## Supplement to

STAR WARS Schematic Package (SP-225, 1st printing) STAR WARS Operators Manual (TM-225, 1st printing) STAR WARS Operators Manual (TM-245, 1st printing)

## STAR WARS Main PCB Parts List

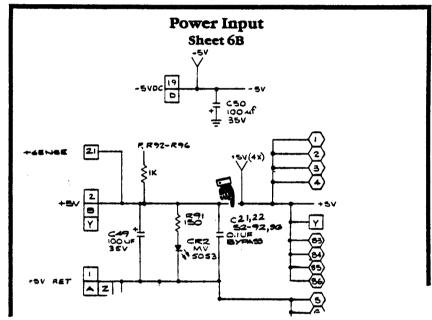
Please add the following correction to SP-225

Figure 5-12 Main Printed-Circuit Board Assembly A038461-21 B

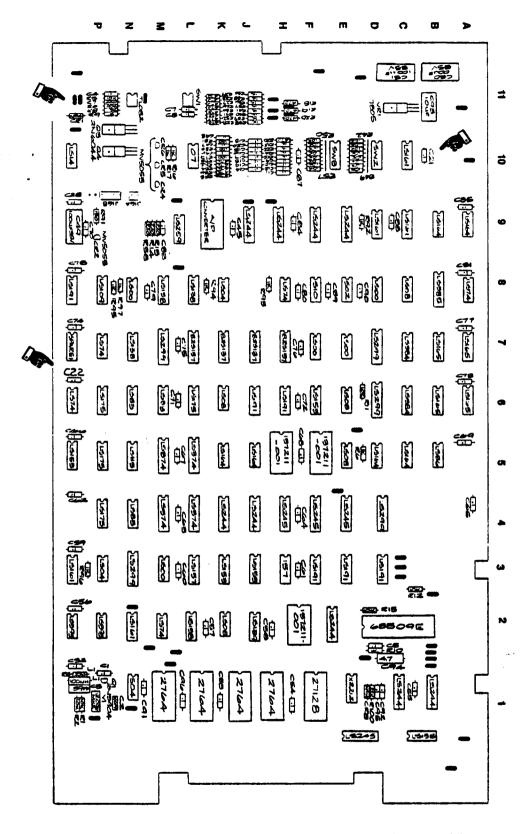
Please make the following changes to the Main PCB parts list of TM-225 and/or TM-245:

Description	Part No.
Capacitors	
0.1 μF, ±5%, 50 V Ceramic Capacitor	122002-104
Integrated Circuits	
300 ns Tri-State EROM Integrated Circuit	136021-101
should be:	
300 ns EPROM Integrated Circuit	136021-114
	Capacitors Add:  0.1 µF, ±5%, 50 V Ceramic Capacitor  Integrated Circuits  300 ns Thi-State EROM Integrated Circuit should be:
